ADDENDUM 2

ADDENDUM DATE: September 1st, 2016

PROJECT: Randolph County Animal Shelter

08/15/16 S3-01

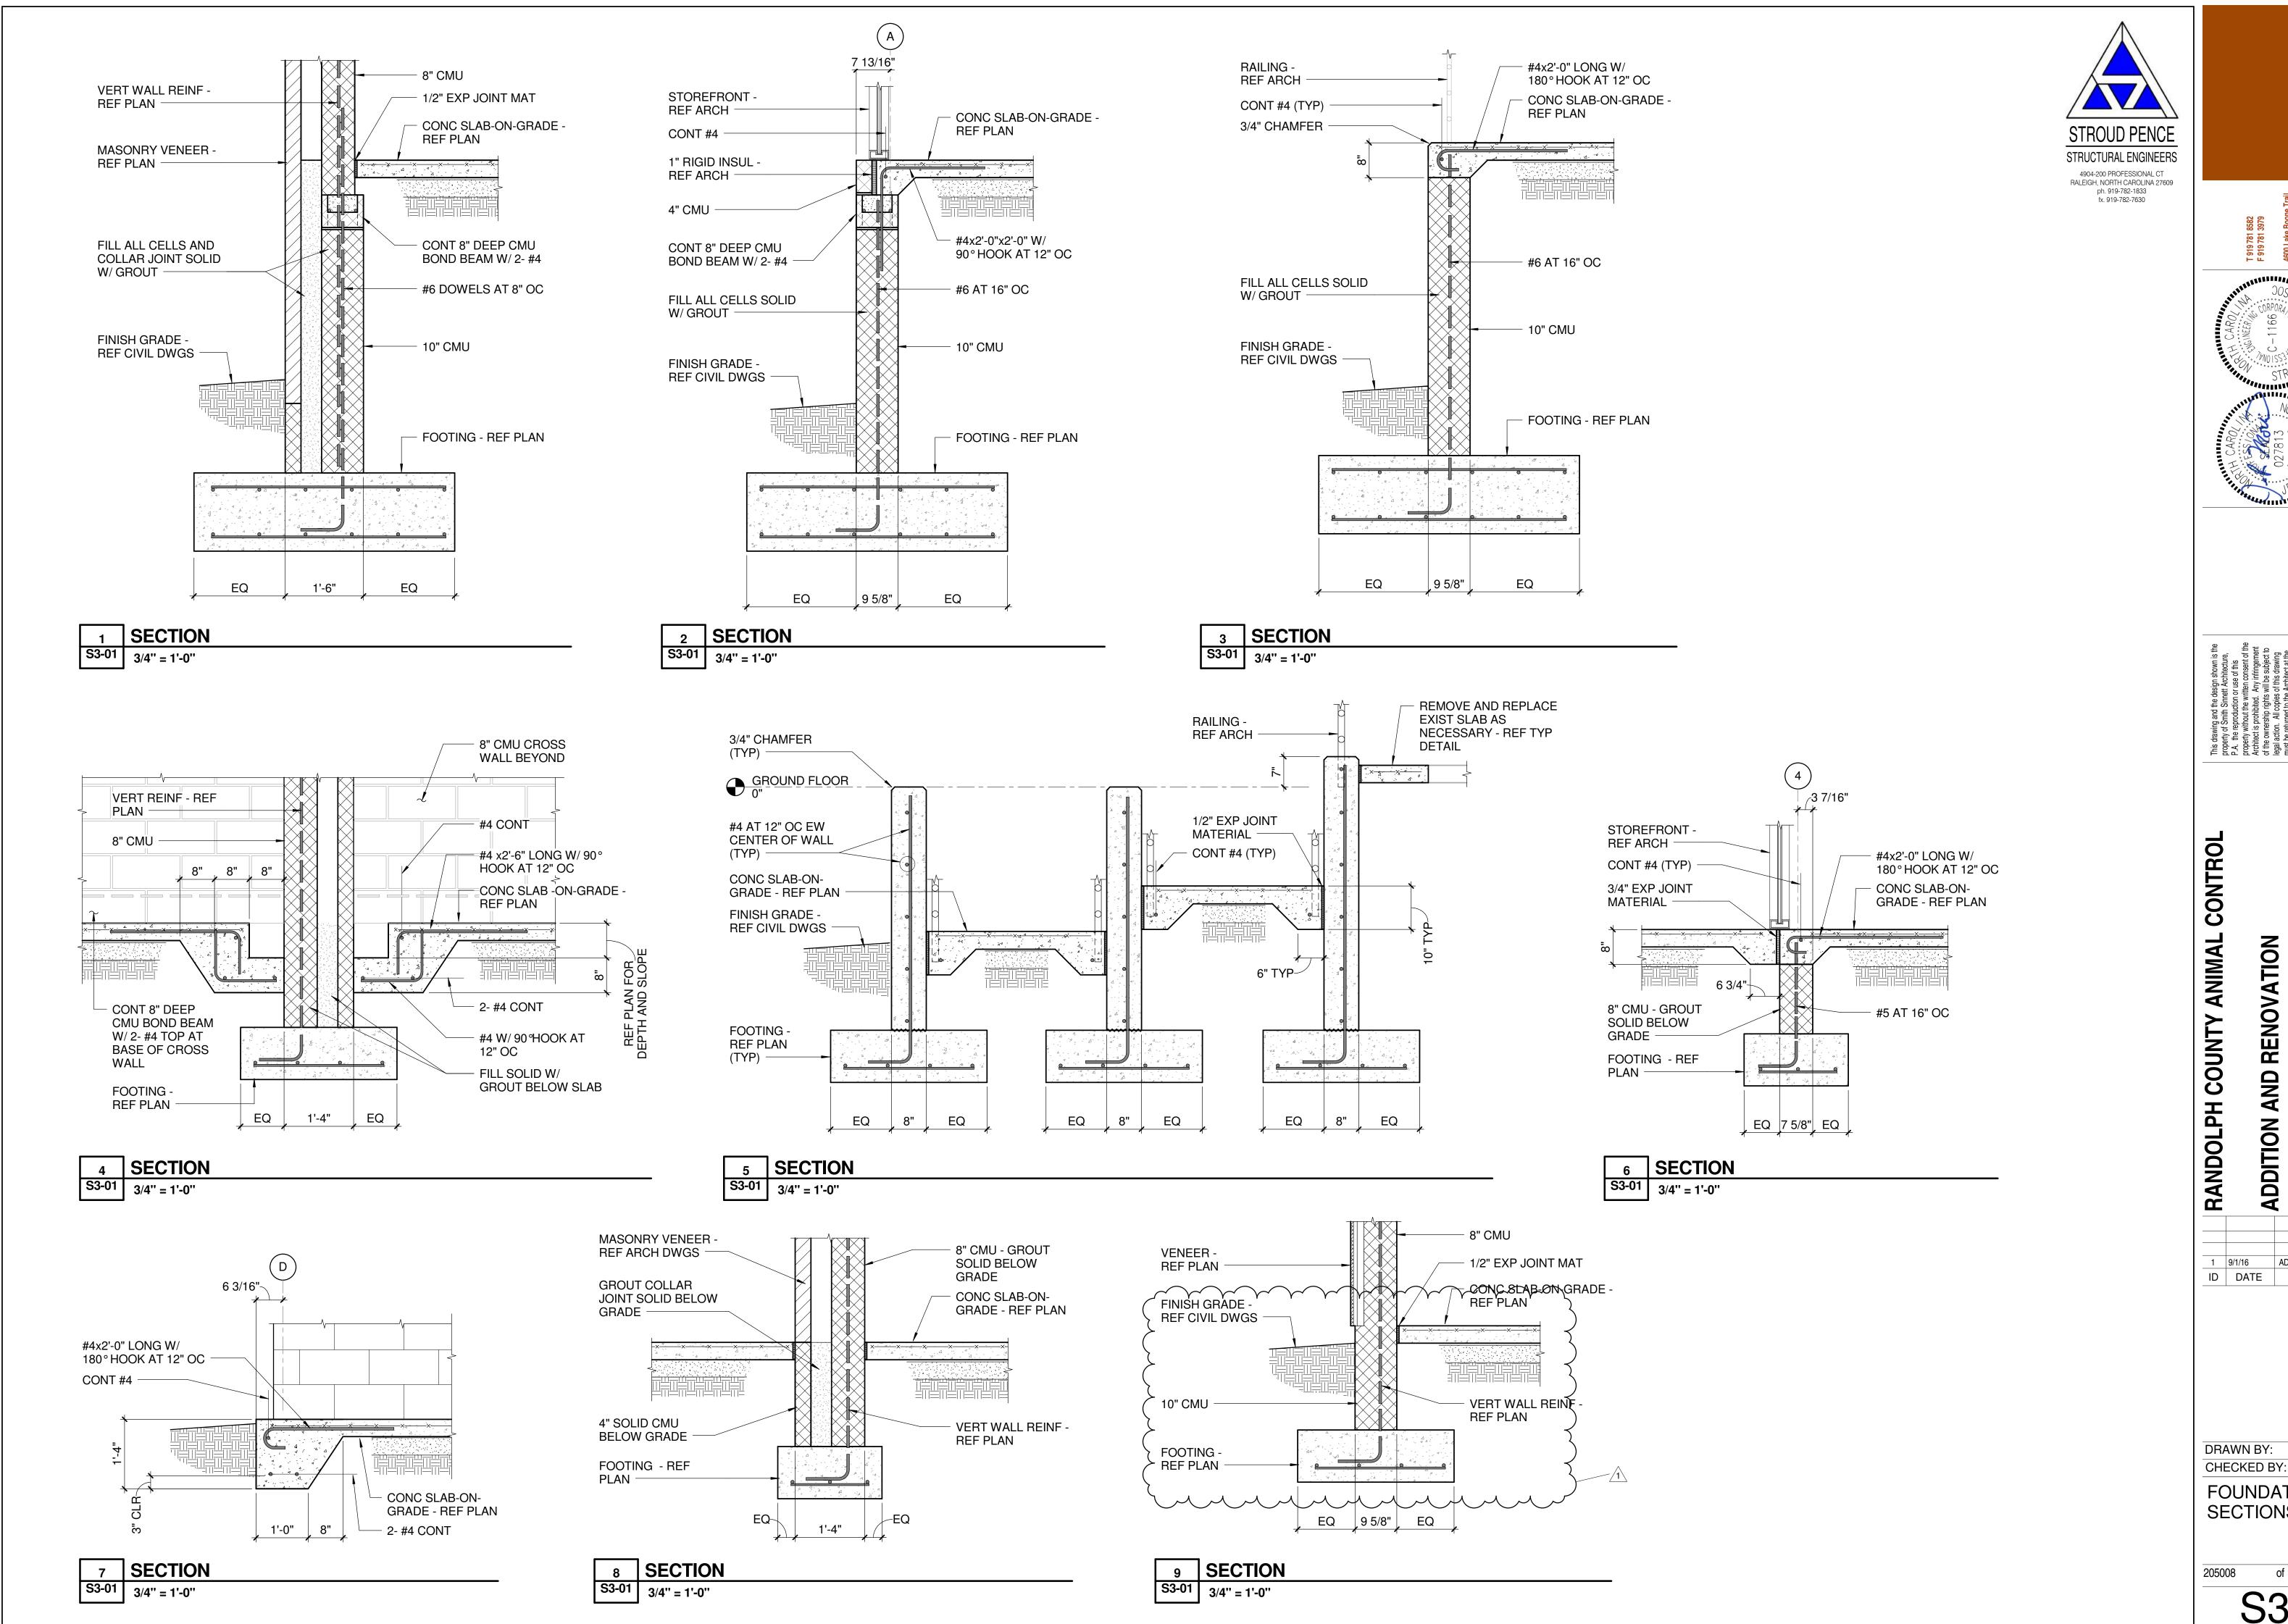
- 11. <u>Clarification</u>: Structural detail 9/S3-01 has been revised to show 10" CMU up to slab level where siding begins at slab level. Above grade, foundation CMU wall and CMU veneer is to be polished/ground faced starting 8" below grade. Grey block extends from footing to 8" Min. below finished grade. See Arch. Details. See attached revised sheet.
